Planning Commission
AGENDA

PLANNING COMMISSION AGENDA REPORT

ARCH-0587-2020, USE-0412-2021, AFFH-0413-2021, & EID-0494-2021 – 279 Bridge Street Planning Commission Report – August 25, 2021

Figure 2: Section Cuts demonstrating compliance with Edge Conditions setbacks, the balconies referenced are located on Section Cut 1, 2 and 4.

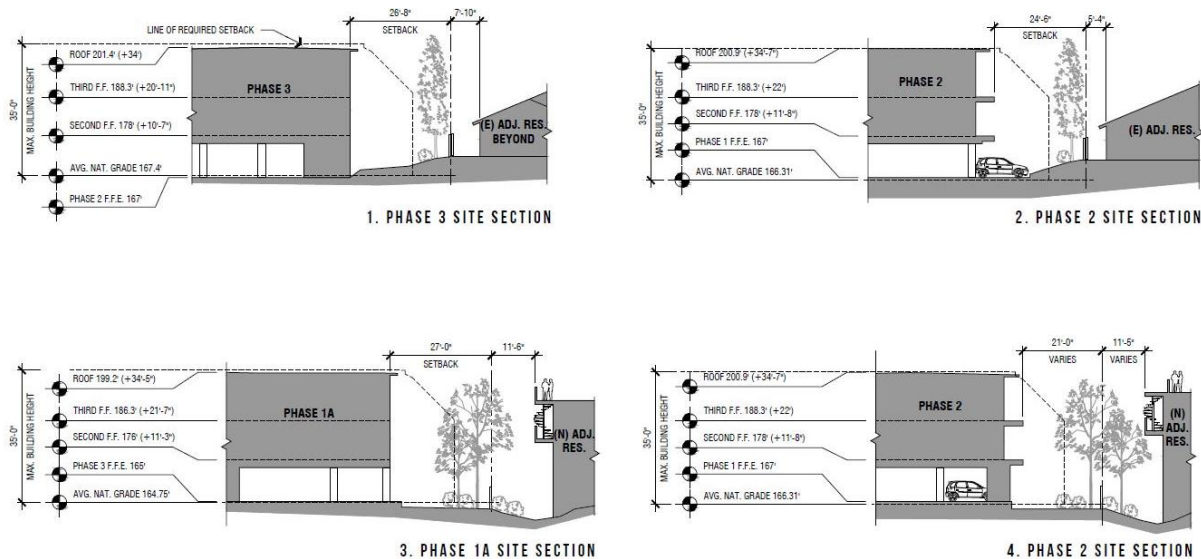
Edge Conditions: The Zoning Regulations § 17.70.050 (Edge Conditions) is intended to provide a buffer between low-density residential zones or open space areas and zones that permit development of higher intensity. These regulations require specific development standards along the property line that transitions from a lower intensity zoning, such as the adjacent R-2 zoning to the east and south of the subject property. The Edge Conditions regulations stipulate that balconies are prohibited above the first floor on the building side facing the R-2 zone (§17.70.050.D.3). The Edge Conditions standards also require that window placement on the proposed building be offset horizontally by 12 inches from any windows located on buildings on the adjacent properties in the R-2 zone (§17.70.050.D.5). The intention of these restrictions is to preserve privacy for adjacent lower-intensity developments. The project is requesting an affordable housing alternative incentive to allow for balconies on the second and third floors on the building side facing adjacent properties that are zoned R-2. The project also includes a waiver from the site development standard that requires window placement to be offset by 12 inches from adjacent existing structures along the second and third floors. The requested alternative incentive and development standard waiver are discussed in more detail in Section 5.3 below.

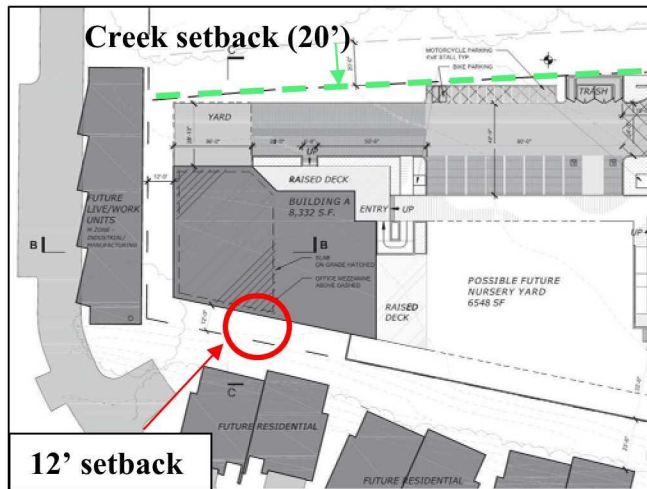
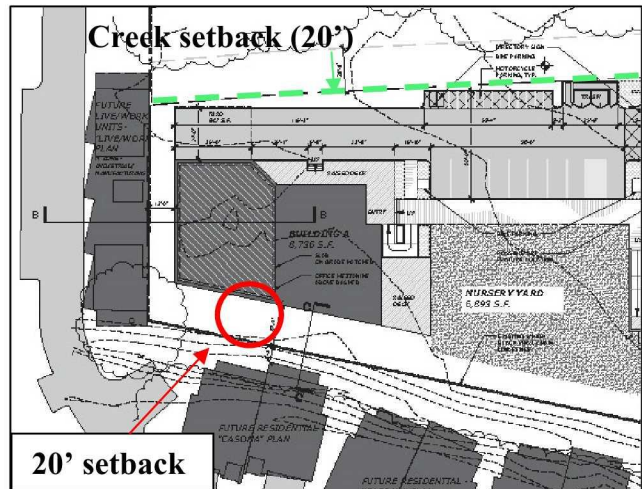
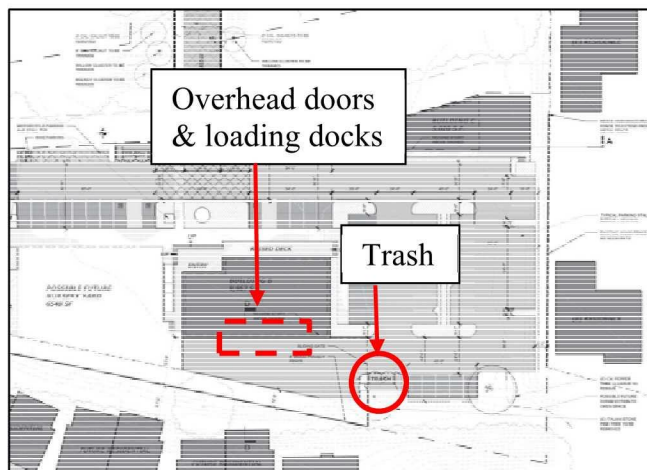
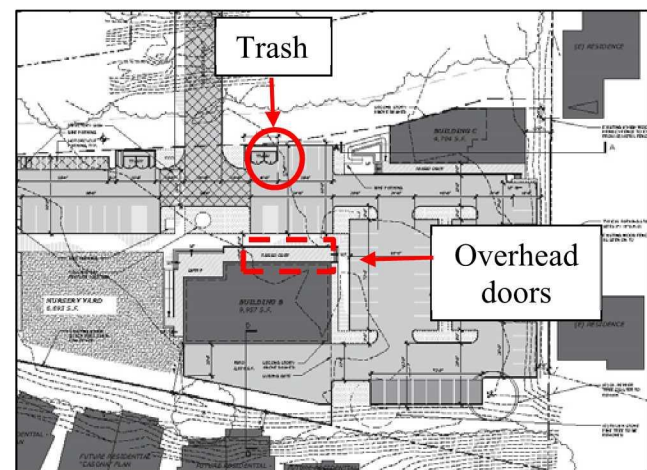
Directional Item #1: Relocate Building A to be further from adjacent residential uses in order to preserve views from the 215 Bridge Street project and providing additional buffering from the proposed commercial building.

Directional Item #2: Relocate loading docks and trash enclosures as far away as possible from adjacent residential uses. Loading docks should be provided on the north side of the proposed buildings or between clustered buildings to buffer noise from adjacent residential uses.

Response: The proposed location of Building A has been shifted eight feet to the north, increasing the building setback from the southern property line from 12 to 20 feet (refer to Figures 1 and 2, below). A planted bioswale and a variety of trees including coast live oak, California sycamore, and desert willow are proposed to be planted between Building A and the western and southern property lines (Attachment 3, Re-submitted Project Plans, Sheet L1). Additional discussion regarding site design and neighborhood compatibility is provided in Section 3.2 Public Comments, of this report.

Response: The overhead doors and loading docks on the south side of Building B (see Figure 3) have been relocated to the north side of the building, facing away from the adjacent residential uses (see Figure 4). Trash enclosures have been relocated from the southern portion of the property, as shown in Figure 3, to the center of the property, north of Building B (refer to Figure 4). The Building A loading dock and overhead door remain on the north side of the building, in
